Doc or ECO #:	ECO-70893-001	Date:	12/07/2020	Author:	SL
	Rev. #:	A				
Engineering Change Order (ECO)	Engineering Approval:	aeg	Date:	12/11/2020	Quality Approval:	aeg

P/N #:	70893	Effective Date:	December 11, 2020
Title:	Pro5 Frame Sonar Mount Tilt Upgrade

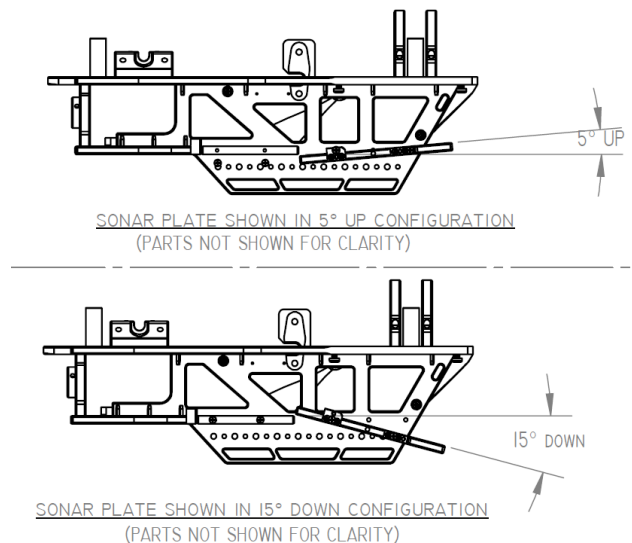
- The purpose of this Engineering Change Order is to increase the feature set of the Mission Specialist Pro 5 Frame by adding a tilt function to the sonar mount plate.

- By modifying the Sonar Mount Plate [70895] to add Positive/Negative tile plates [72391 + 72392] (x 2 each) and utilizing the exiting unmodified frame, the sonar can now be angled at a 5 degree positive or 15 degree negative pitch for varying target acquisition requirements.
